Premstaetten, July 20, 2018

DR PCR 04 (Change of final device test location to the current assembly house and consequently the final product label)

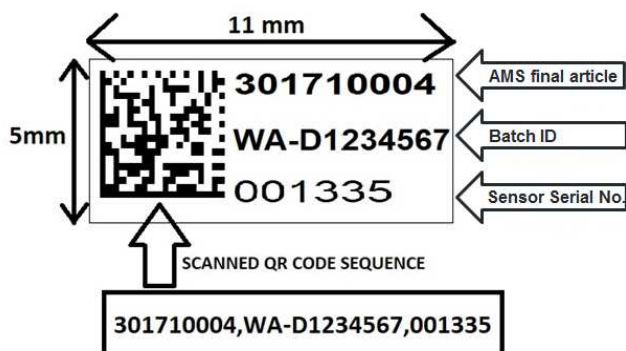
To improve the testing method, and to have more details of the sensors included in the logging, a new label design has also been implemented.

The label is of dimension 11 mm X 5 mm and features a QR code with the read out sequence as shown in the image below:

On the label is printed the following information:

- ams final article number
- batch ID from assembly house
- sensor serial number.

This label will be located on the front side of the sensor.
